MRP-335R2 Topical Report for PWSCC Mitigation by Peening Surface Stress Improvement

**Public Meeting to Discuss MRP Comments
on the NRC Draft Safety Evaluation**

**NRC Offices, Rockville, Maryland
December 9, 2015**

DMW — Azimuth of Maximum Global Bending Stress

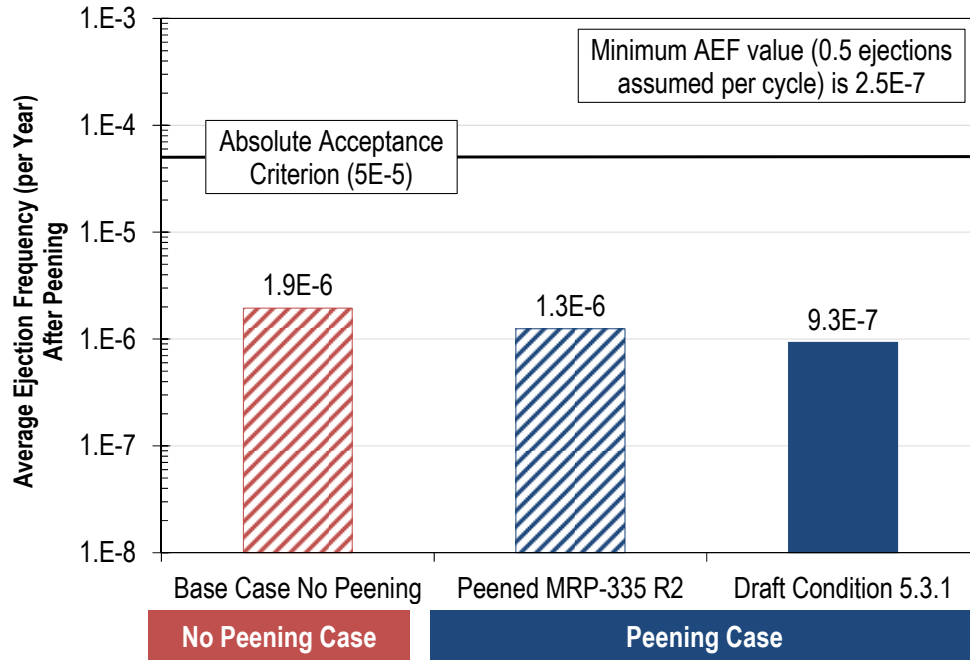
- Effect of draft Condition 5.3.1 modeled by assigning a greater value for the compressive residual stress depth and a more compressive peening surface residual stress
- Average ejection frequency (per year) of $5E-5$ corresponds to a core damage frequency of no greater than $1E-6$
 - NRC’s published definition of acceptably low risk

Cold Head — Ejection

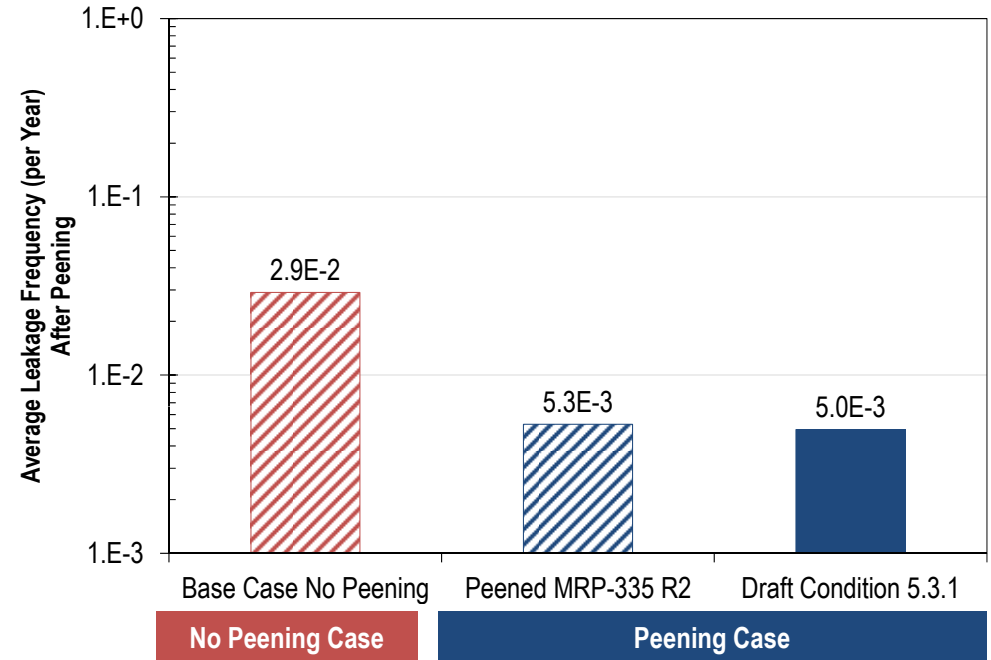
Improved risk with peening per MRP-335R2 versus unmitigated case with current inspection intervals, including about order of magnitude improvement in leakage risk

Condition 5.3.1 provides only limited risk benefit for peened RPVHPNs and DMWs
